ADDENDUM No. 1
Request for Competitive Sealed Proposals (CSP)
19CSP085- Renovations at Casey Elementary

CASEY ELEMENTARY SCHOOL
RENOVATIONS AT CASEY ELEMENTARY SCHOOL

ADDENDUM NO. 01: December 21, 2018

Sheet: M0.1

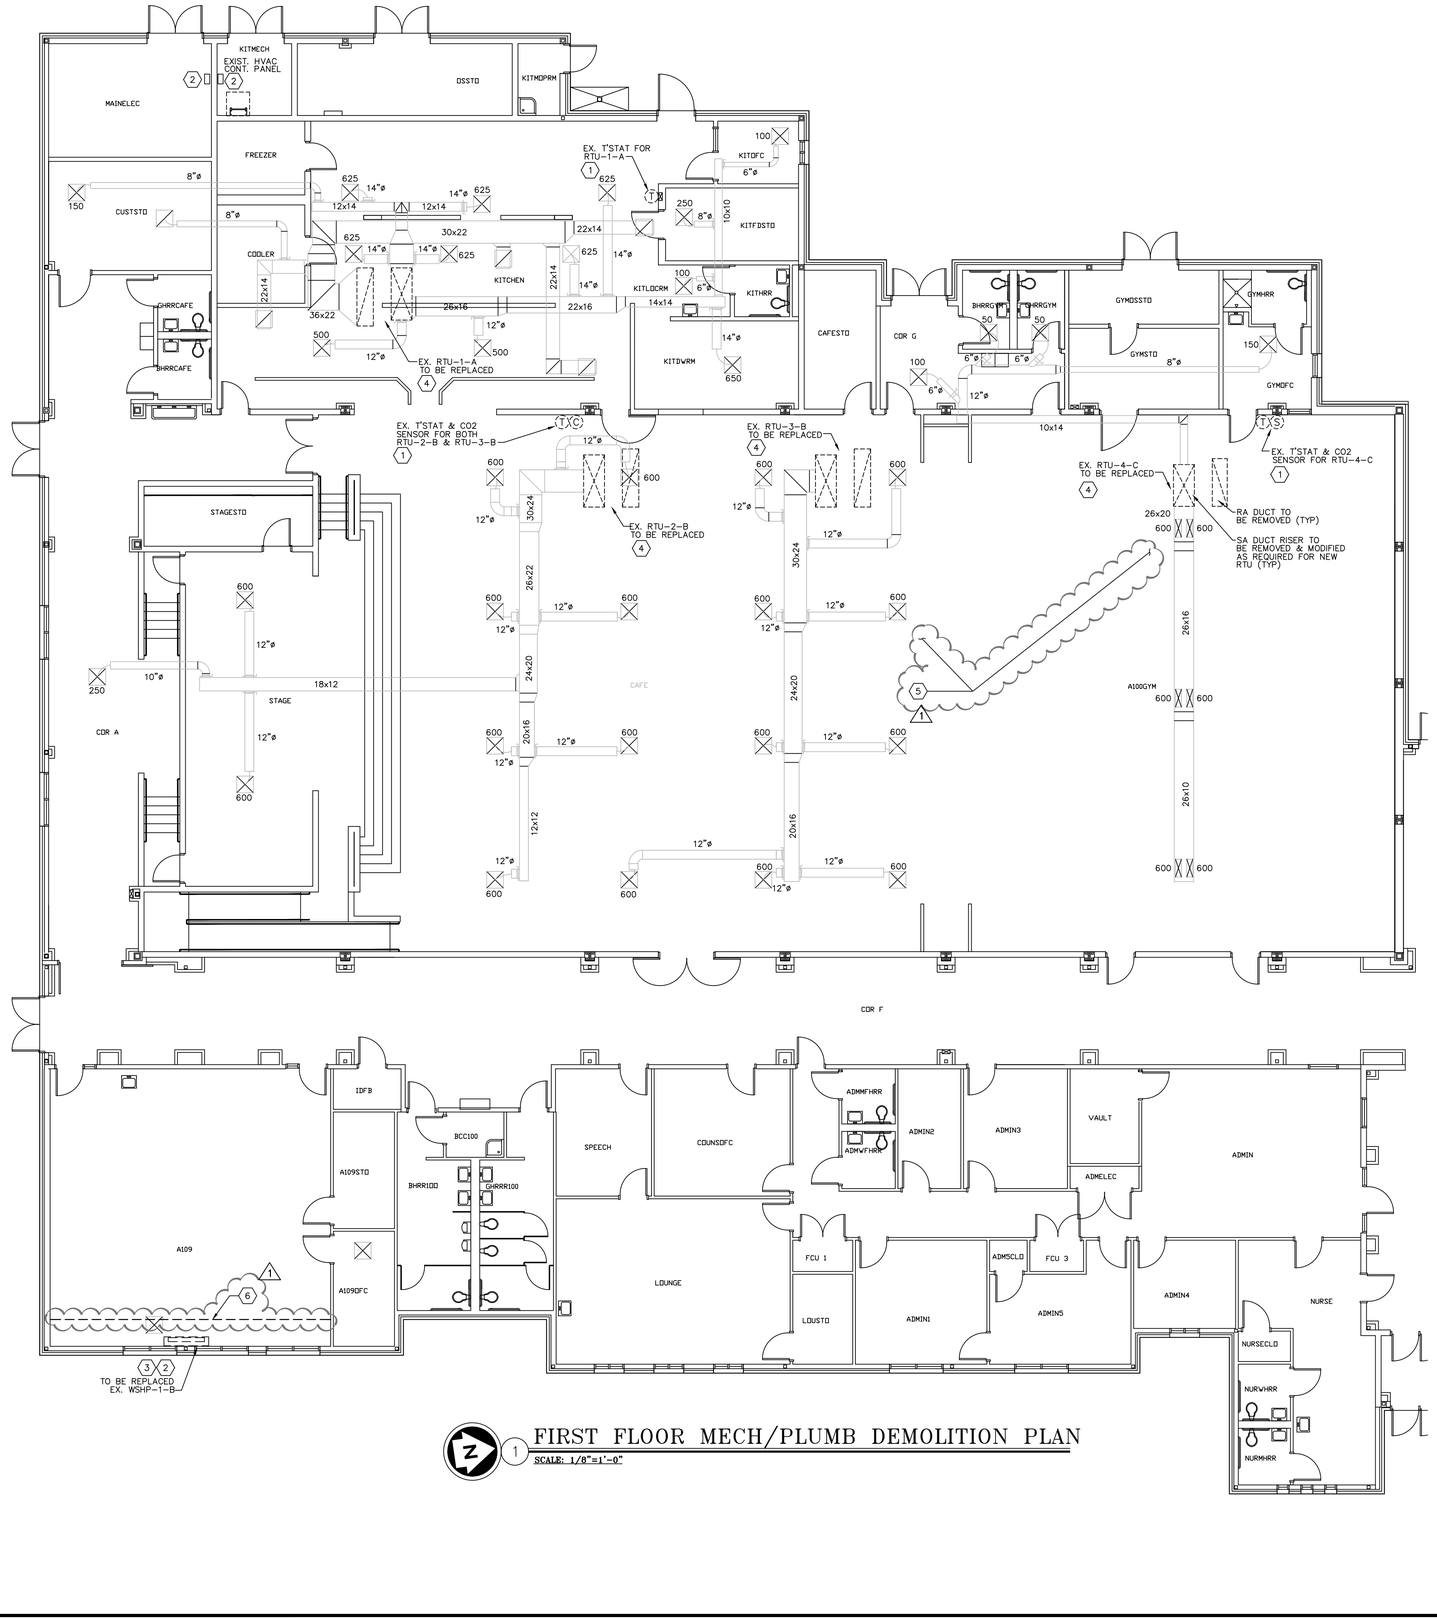
1. M0.1
   Updated drawing index and Revised Note 14

Sheet: **MP3.1**

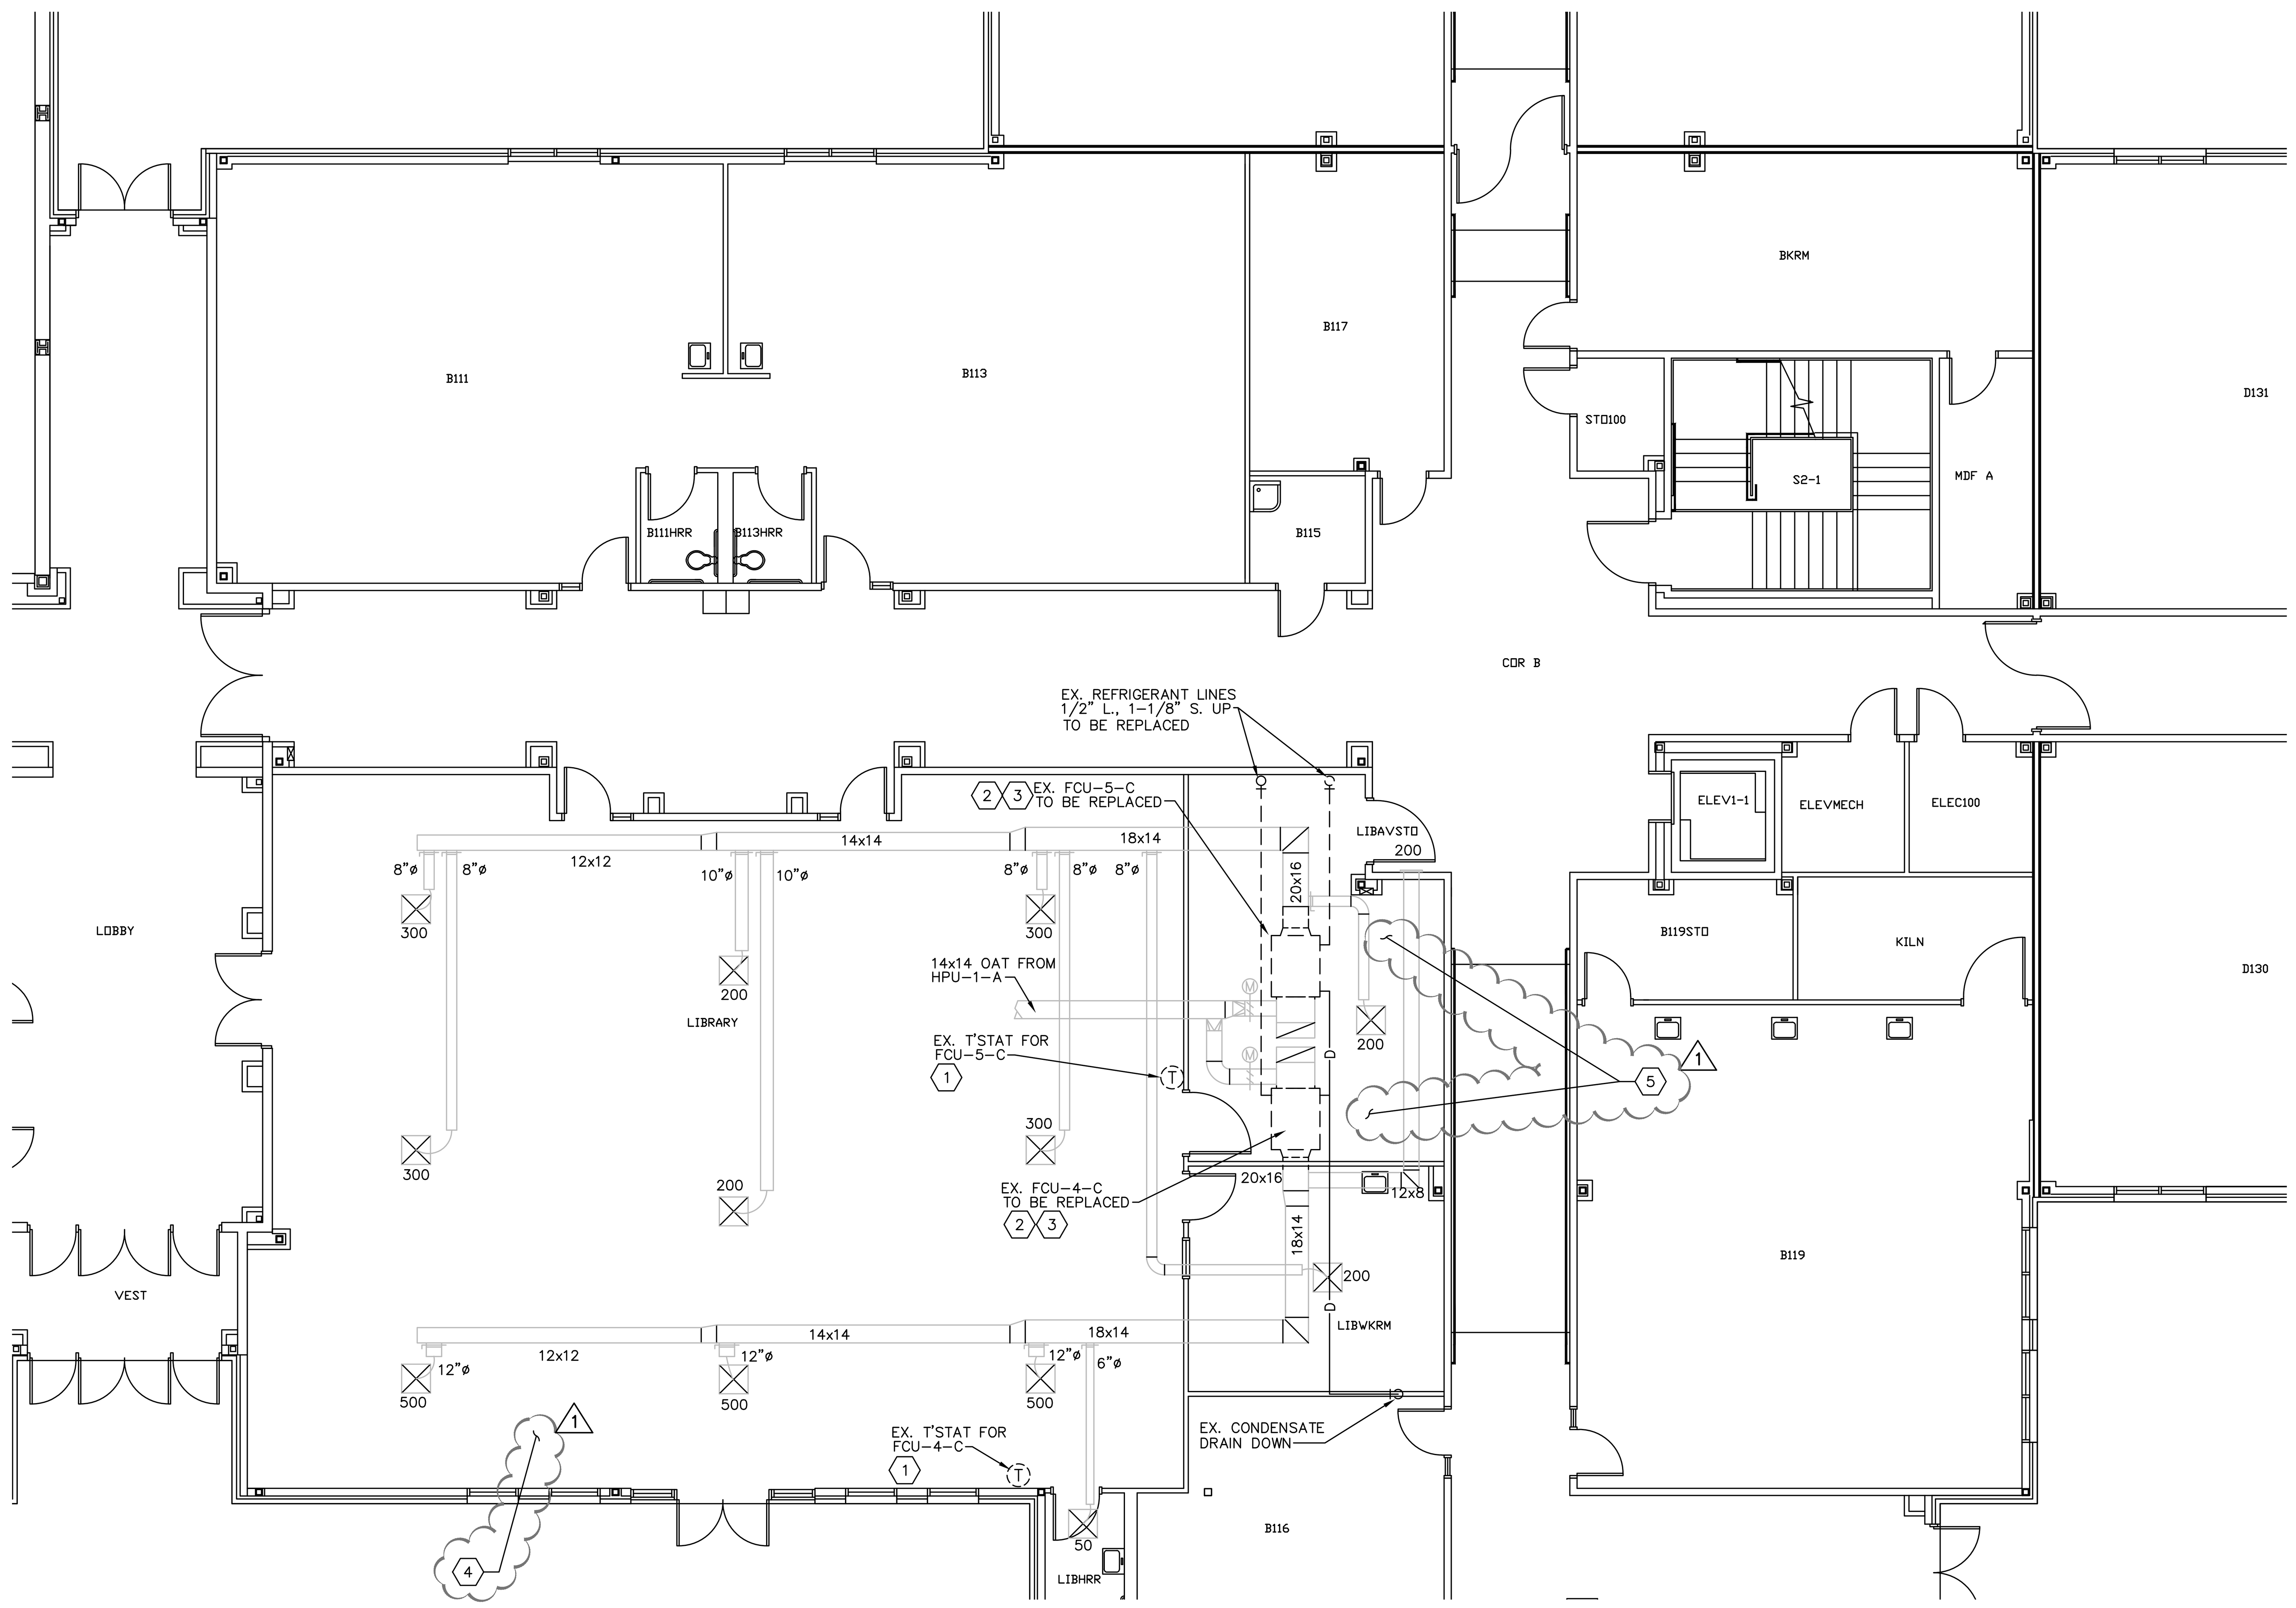
2. MP3.1
   Added Keyed Notes 5 and 6 to indicated work associated with ceiling and floor to support the MEP work.

Sheet:
MP3.2

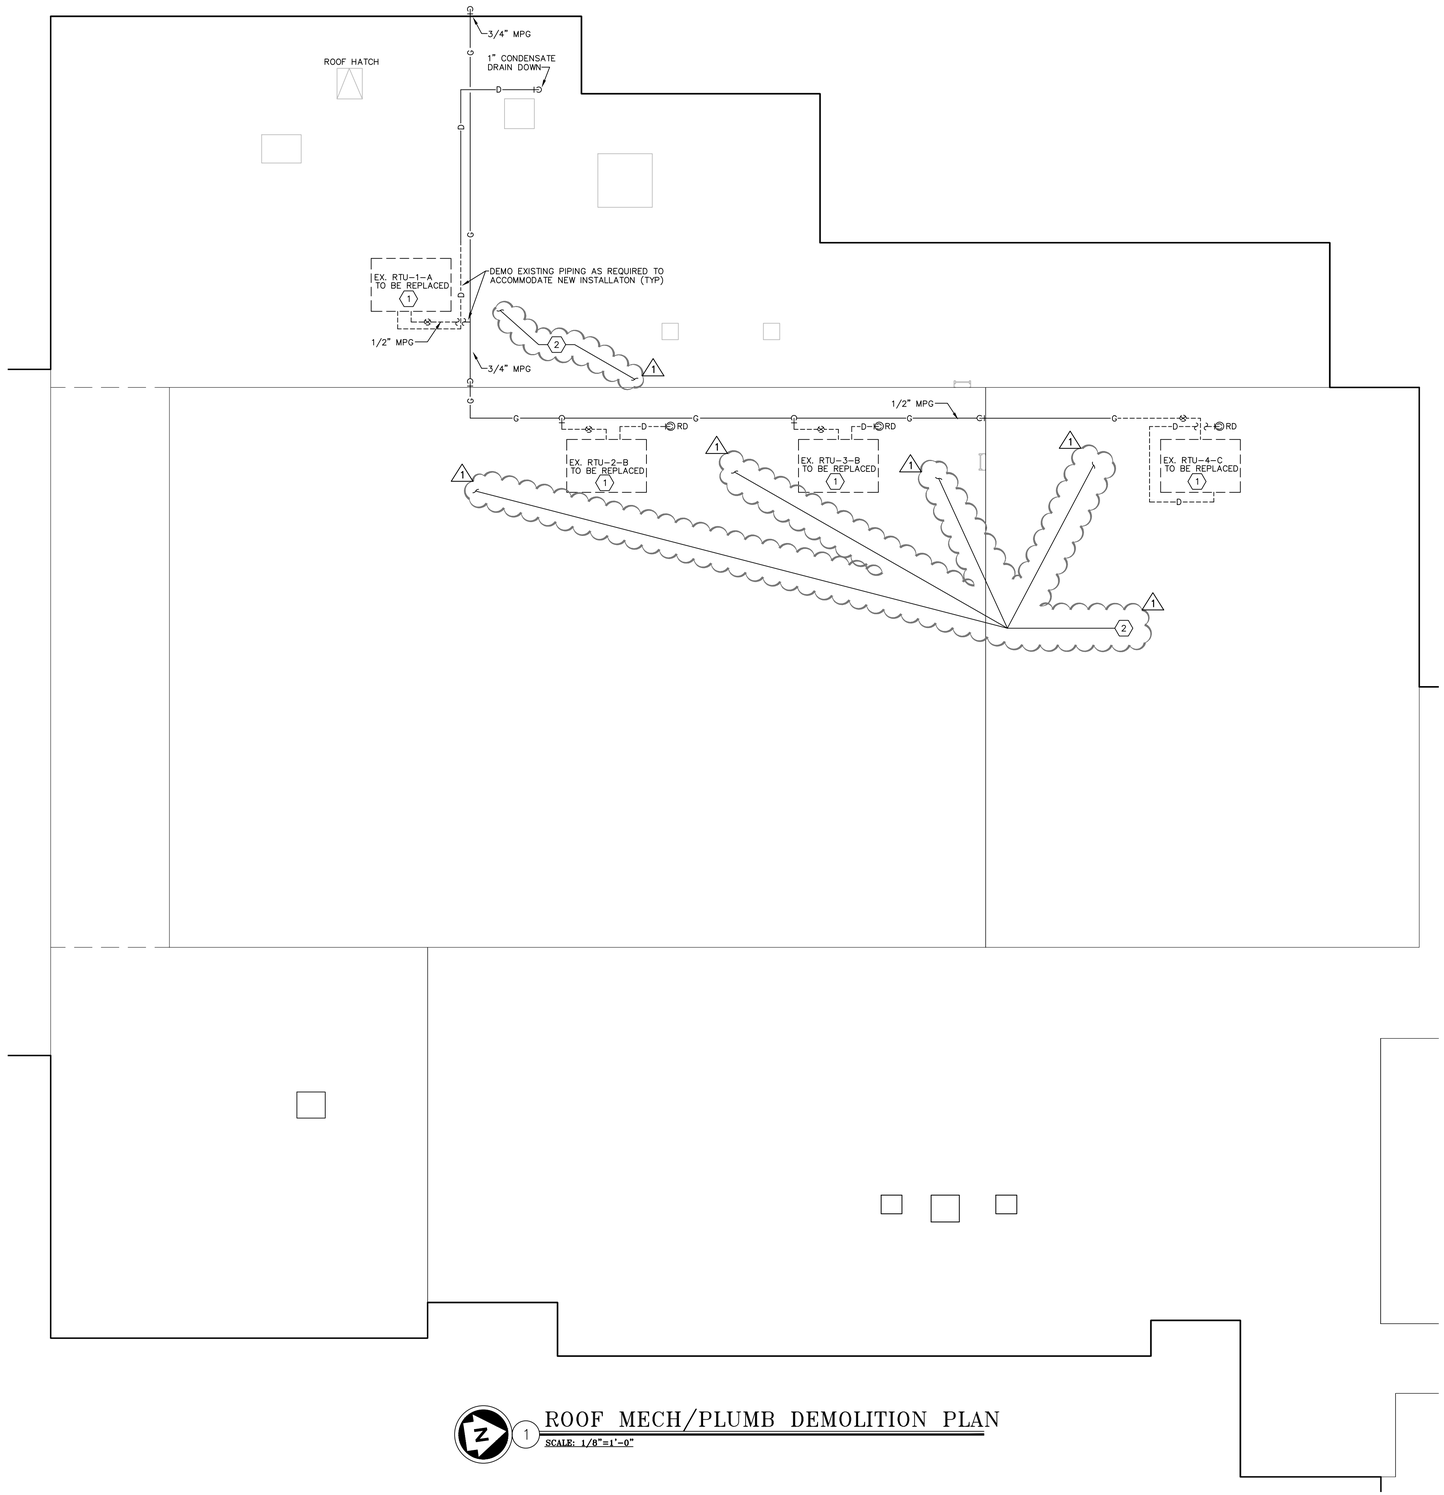
3. MP3.2
   - Added Key Note 4 to indicate the requirement for temporary cooling in the library during construction.
   - Added Key Note 5 to indicate work associated with ceiling.

Sheet: **MP3.4**

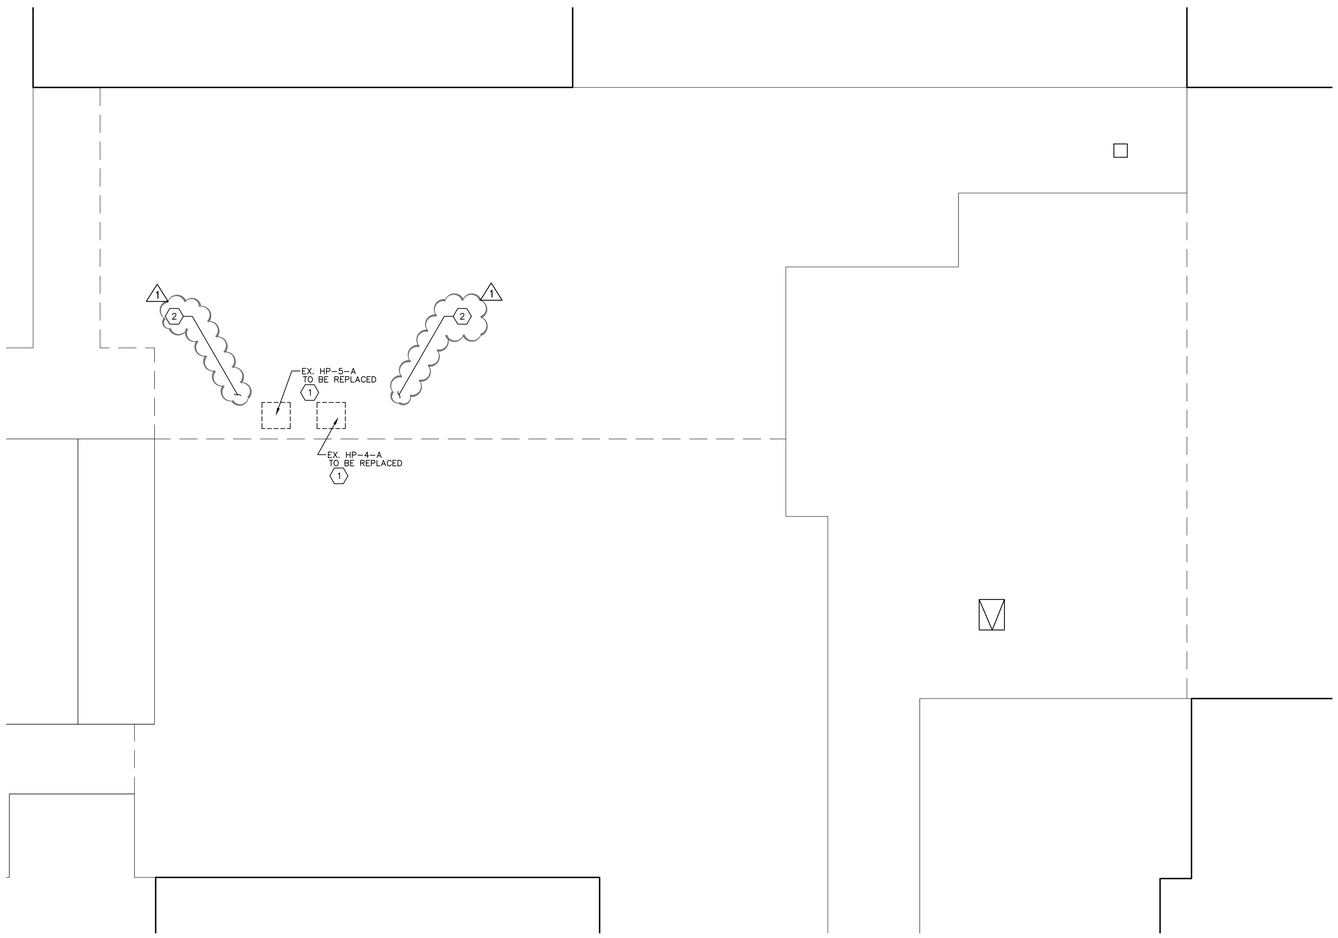
4. MP3.4
   - Added Keyed Note 2 to indicate that plywood is to be used to protect the existing roof during construction.

Revised requirement in Construction Note 3.c. for work associated with condensate piping.
5. MP3.5
   - Added Keyed Note 2 to indicate that plywood is to be used to protect the existing roof during construction.
